# FEDERAL AVIATION ADMINISTRATION AIRWORTHINESS DIRECTIVES LARGE AIRCRAFT

#### **BIWEEKLY 2000-06**

# FIGURE 1

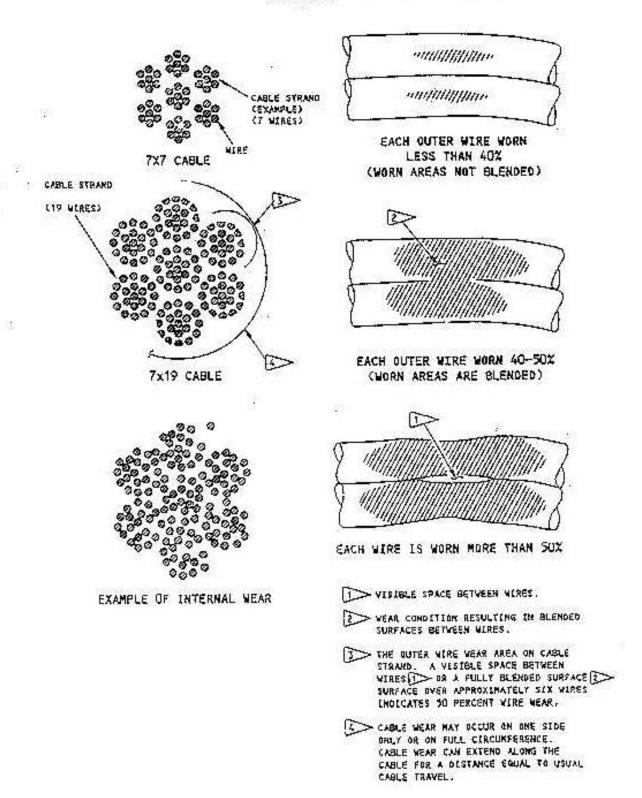
(a) For all airplanes: Within 18 months after the effective date of this AD, accomplish the "Thrust Control Cable Inspection Procedure" specified in Appendix 1. (including Figure 1) of this AD to verify the integrity of the engine thrust control cables. Prior to further flight, replace any discrepant component found, in accordance with the procedures described in the Boeing 747 Maintenance Manual. Repeat the detailed visual inspection thereafter at intervals not to exceed 18 months.

- One cable strand had worn wires where one wire cross section is decreased by more than 40 percent (see Figure 1),
  - (2) A kink is found, or
  - (3) Corrosion is found.
